RE: Shady Hills Generating Station – Permit PSD-EPA-R4013

RE: COMMENTS TO US EPA SHADY HILLS GENERATING STATION AIR PERMIT PSD-EPA-R4013

Draft PSD Permit for Greenhouse Gas Emissions Permit PSD-EPA-R4013

Figure 1. Hours of Operation for Combustion Turbines, by Year⁵

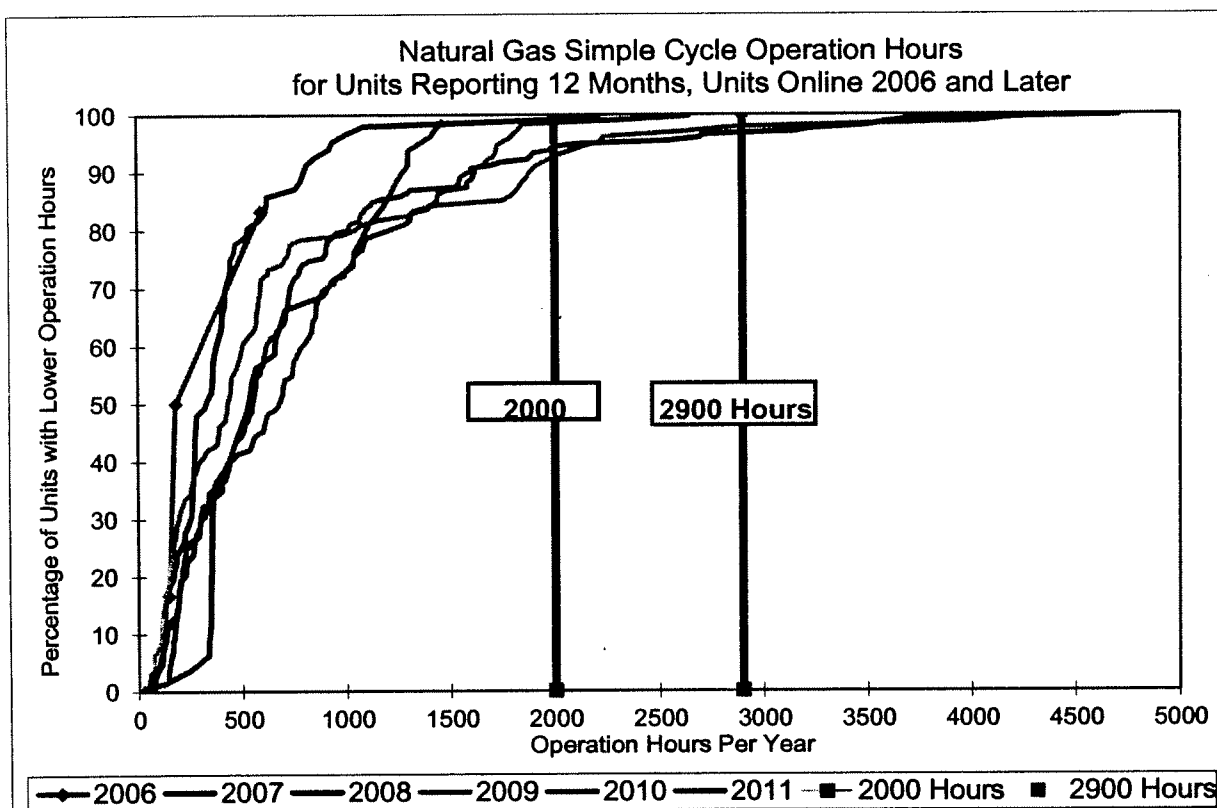
The Region states that “Shady Hills is a peaking plant” and “Electric utilities primarily use simple-cycle combustion turbines as peaking or backup units.” (SOB at p.13.) However, the annual operating hours for all of the proposed units are much higher than typical peaking units. The available data show that almost all simple cycle combustion turbine units have low operating hours – but they also appear to show that a few large simple cycle units have high capacity factors. The SOB assumed that the Shady Hills Project would operate 3,390 hours per year. This is far more operating hours than peaking units, and the high operating hours limits demonstrates that the Applicant is attempting to avoid using a more efficient combined-cycle unit. The histogram in Figure 1 shows that the annual operating hours in the proposed permit are too high. The “knee in the curve” for these data appears to be below 2000 hours for 2011 (the most favorable⁴ year for industry), thus showing that operation greater than 2000 hours is not consistent with the normal operation of simple cycle units.

We note that even 2000 hours of operation may represent simple cycle units that are in intermediate load rather than peaking operation, especially if such use is seasonal. We also note that there are a substantial number of combined cycle units that are designed for intermediate load applications but that may have limited hours of operation because of market conditions. Eighty-two of the 592 recently constructed combined cycle units in the EPA CAMD data set, Figure 2, operate less than 2000 hours per year; 143 of those units operated less than 2900 hours per year. These figures show that a typical simple-cycle unit almost never operates at or above 3,390 hours per year. This begs the question of why the Applicant would propose such a high operating limit unless it was claiming to be a peaking unit for the express purpose of trying to avoid a BACT limit based on a combined-cycle unit.

Figure 2. Hours of Operation for Combined Cycle Units

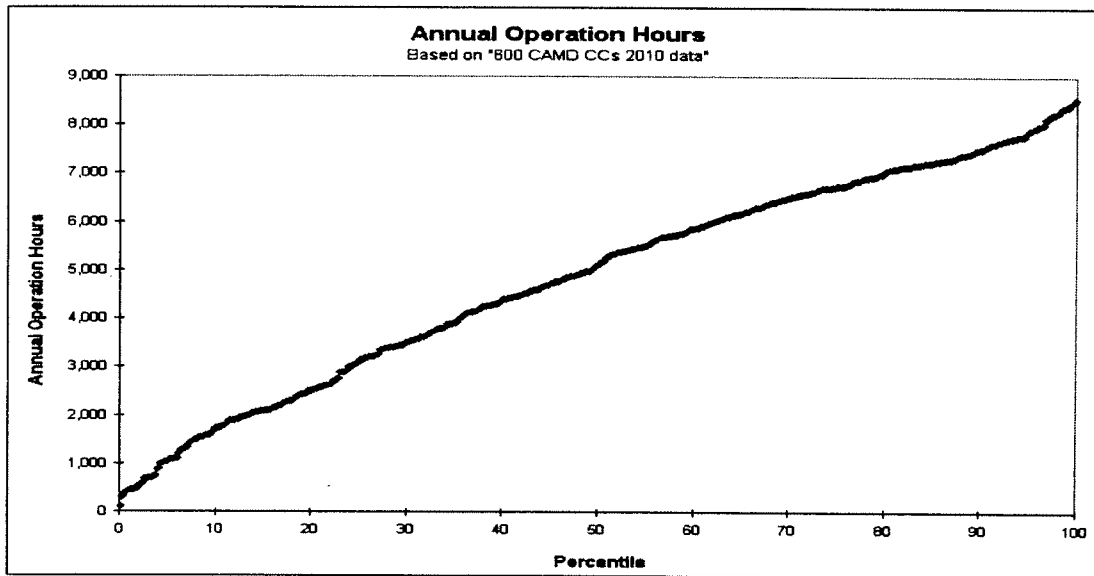
Figure 2 data suggest that an hour of operation assumption above 2,000 hours does not sufficiently differentiate peaking from intermediate-load units. Intermediate units may operate seasonally, but for many hours at a time once started up. Such intermediate units are seasonal or load following, and these units are not true peaking units. In the draft permit, the Region must set the operational hours based on the characteristics of a peaking unit because it expressly rejected consideration of combined cycle units on the grounds that the Applicant needed the Shady Hills Project for peaking power generation. (SOB at p.13.) If the Applicant plans to operate the Shady Hills Project as an intermediate resource rather than a peaking resource, then the BACT analysis must fully consider combined cycle units as a feasible alternative.
